20150368.2/2810A/R1/TA

Lakes Business Park Rezoning - Aircraft Noise Intrusion - Supplementary Report

This report has been prepared to address comments provided by the Department of Planning in addition to supplementing the original Noise Impact Assessment Prepared for the Lakes Business Park (ref: 20150368.1/1405A/R1/TA)

Figure 1 – Aircraft Noise Exposure Study Area

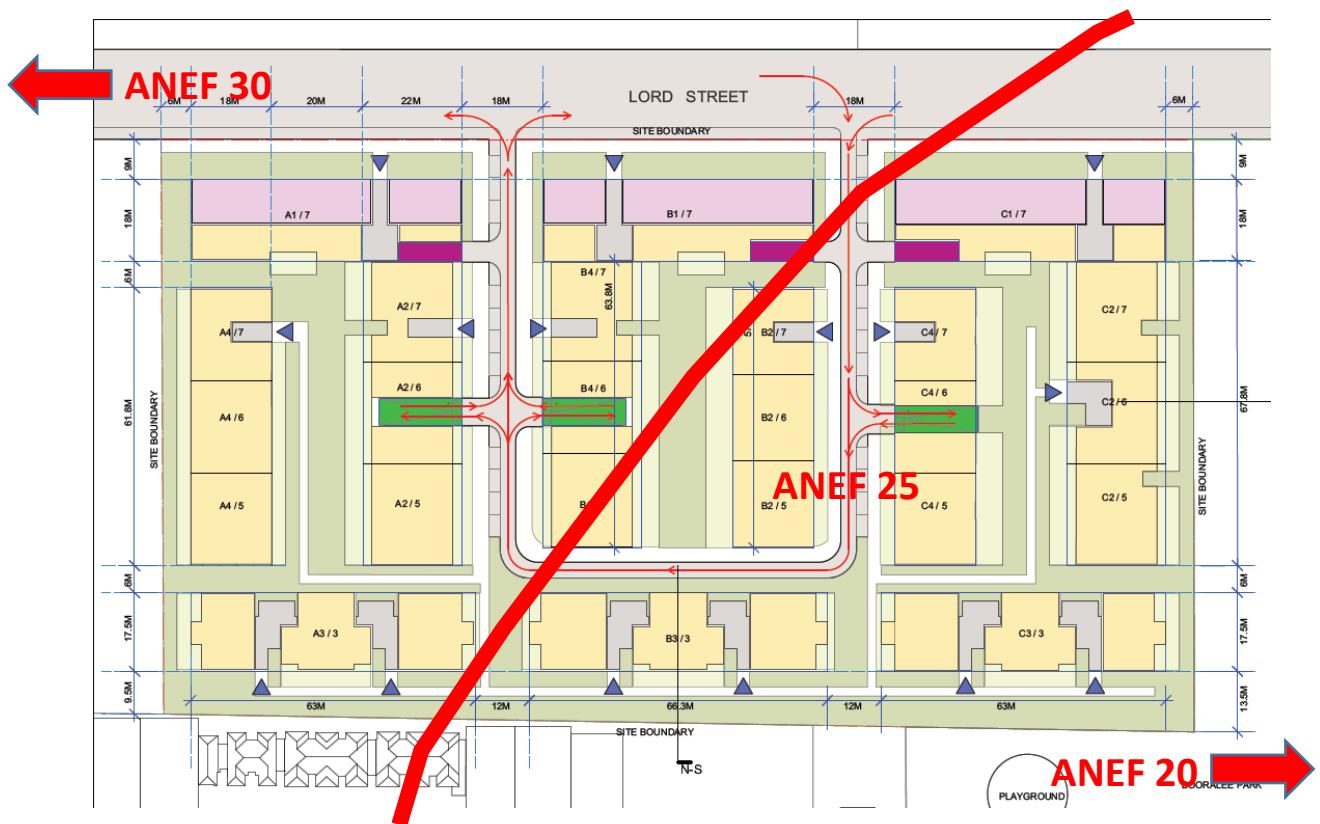
1. Proposed ANEF noise impacts –provide a clear map of location of the proposal in relation to the ANEF contours (it seems to fall largely within the 25-30 ANEF) and justification in relation to the S117 Direction 3.5 Development Near Licensed Aerodromes as to how the aircraft noise will be dealt with;

The map presented in Figure 1 presents the current Masterplan for the Lakes Business Park site with the ANEF2 25 contour which divides the site. As stated within the original noise impact assessment, the current ANEF2033 maps indicate that the site is located on the ANEF 25 contour, with the eastern portion of the site within the ANEF 20 – 25 site area and the western portion of the site within the ANEF 25-30 site area. This is in contrast to the superseded ANEF2029 map, where the entire site was contained within the ANEF 25-30 site area. This indicates that the forecast noise level exposure at the site has decreased since the production of ANEF2029 in 2009. This long term trend is likely to continue given Sydney Airport has a cap on aircraft movements, and that new generation aircraft, such as the A380, are quieter than the current generation of aircraft on which the current ANEF contours are based.
